RESPONSES TO COMMENTS ON THE DRAFT ENVIRONMENTAL IMPACT REPORT (VOLUME 2, ATTACHMENTS A & B)

Better Market Street Project EIR

PLANNING DEPARTMENT
CASE NO. 2014.0012E

BETTER MARKET STREET PROJECT EIR RESPONSES TO COMMENTS

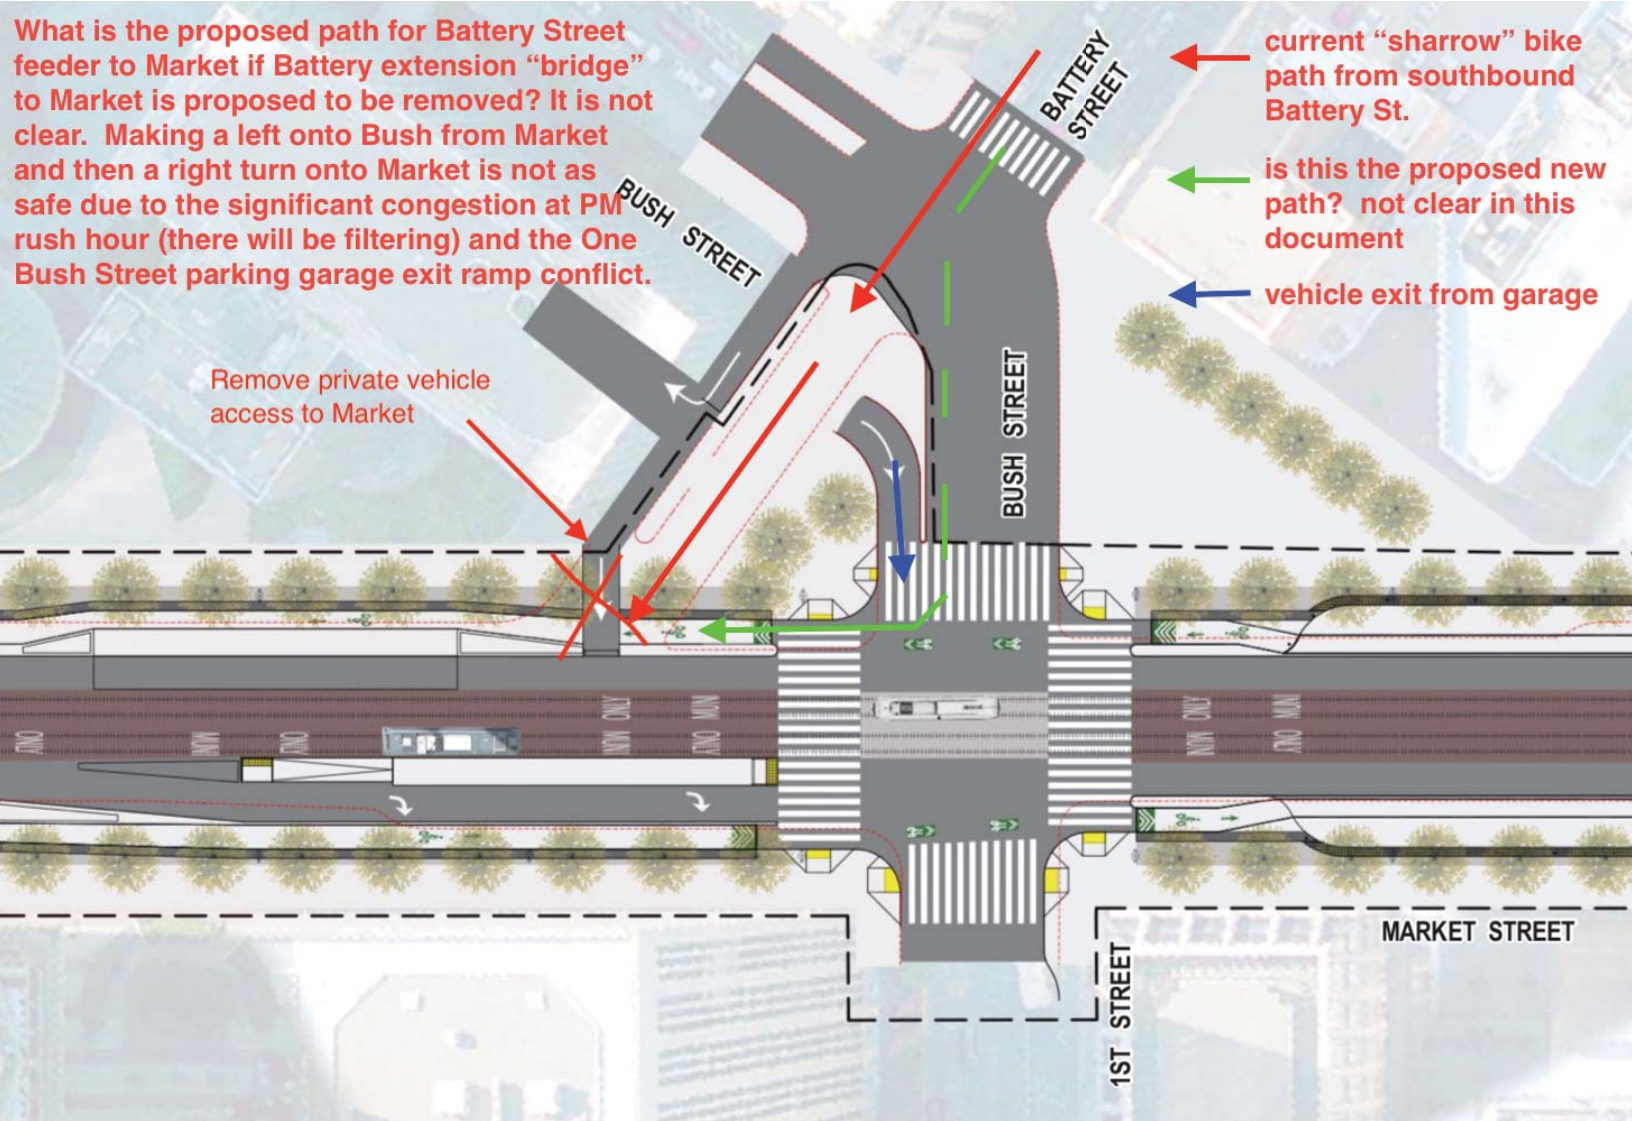
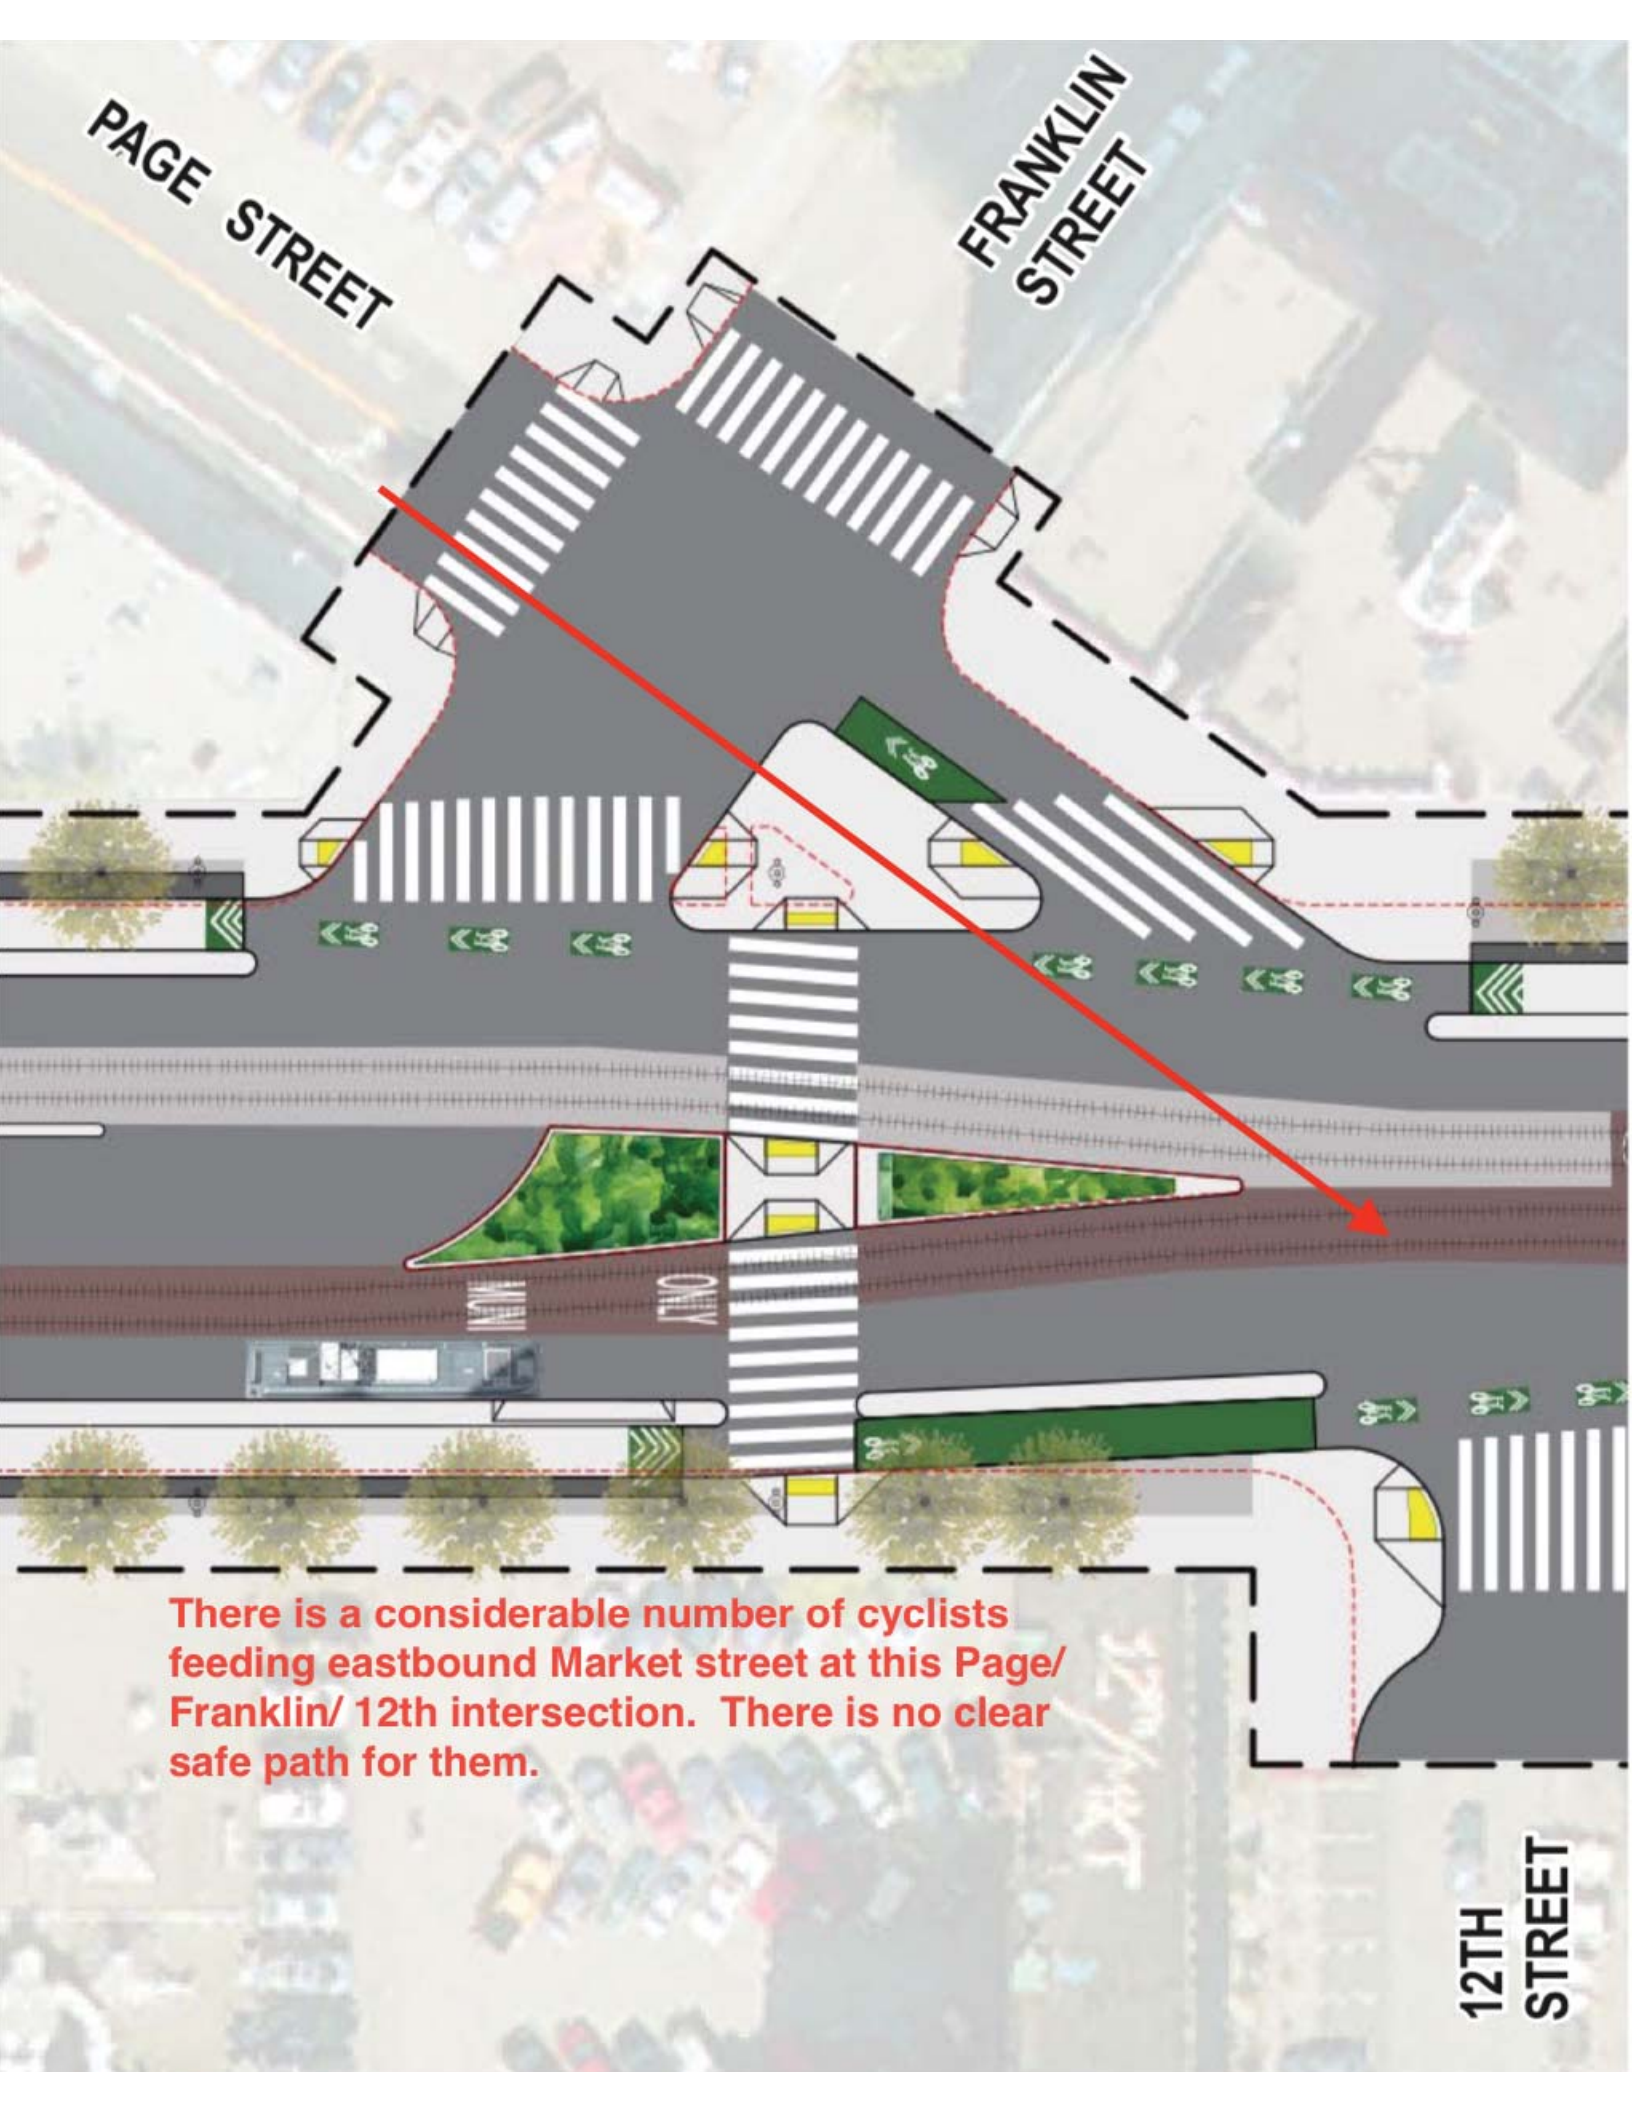
1. Bike Safety: Bike path merge from Battery Street to westbound Market. I see there is a proposal to remove the Battery street extension "bridge" at the one Bush Street garage access point. As much as I support that proposed vehicle path restriction, it also takes away the shared bike lane. There are several cyclist who use Battery street, me being one of them, and the removal of that creates a more dangerous bike connection to market by having to merge, and most likely filter through, massive grid lock at this intersection at PM rush and conflicting with parking garage exit ramp. See diagram attached. I propose creating a dedicated bike lane extension from Battery to Market over the One Bush street garage exit ramp at part of the new pedestrian plaza.

2. Bike Safety: Bikes merging from Page street to Eastbound Market. I see the proposed project does not accommodate the considerable number of cyclists feeding market from Page in the morning rush. This intersection is not really safe now and in the proposed plans I don't see it making it better or safer. This important intersection connection should be revisited to accommodate this EB feeder path. See diagram attached.

What is the proposed path for Battery Street feeder to Market if Battery extension "bridge" to Market is proposed to be removed? It is not clear. Making a left onto Bush from Market and then a right turn onto Market is not as safe due to the significant congestion at PM rush hour (there will be filtering) and the One Bush Street parking garage exit ramp conflict.

Figure 1: Transit stop comparison. (Source: DEIR App. 11—*Better Market Street Final Report*, 2013; pp 18-19.)

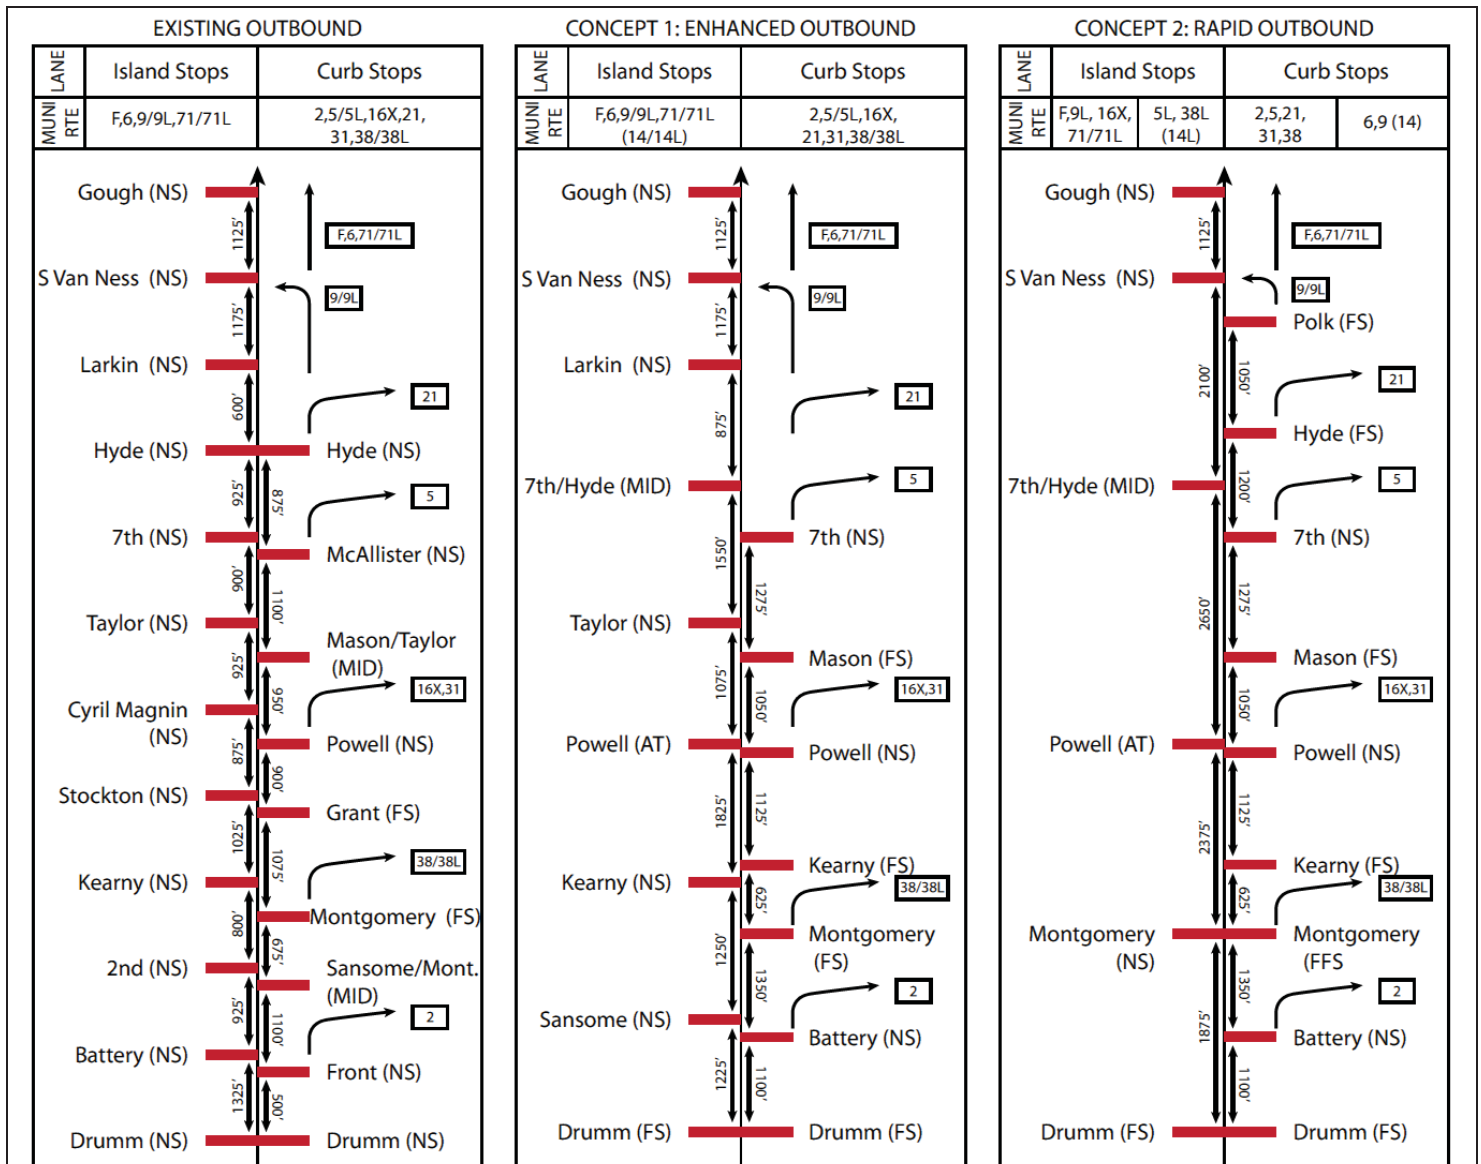
In 2013, when this proposed stop spacing was first suggested (“Rapid” stop spacing), it was proposed in conjunction with an awkward set of line assignments that separated paired Rapid from Local lines. (See Figure 1, from DEIR Appendix 11.) We concurred with staff when this set of line assignments was abandoned in favor of the more legible and convenient assignments associated with the so-called “Enhanced” stop spacings. However, staff did not then revert to those “Enhanced” stop spacings (Concept 1) that had been associated with the paired line assignments.

A close examination of the staff proposals show that Muni is squeezed at Fourth Street between BART entry structures and the proposed surface bikeways in a manner that appears to give lowest priority to providing an island Muni stop at this and possibly other locations. This raises questions as to the design of
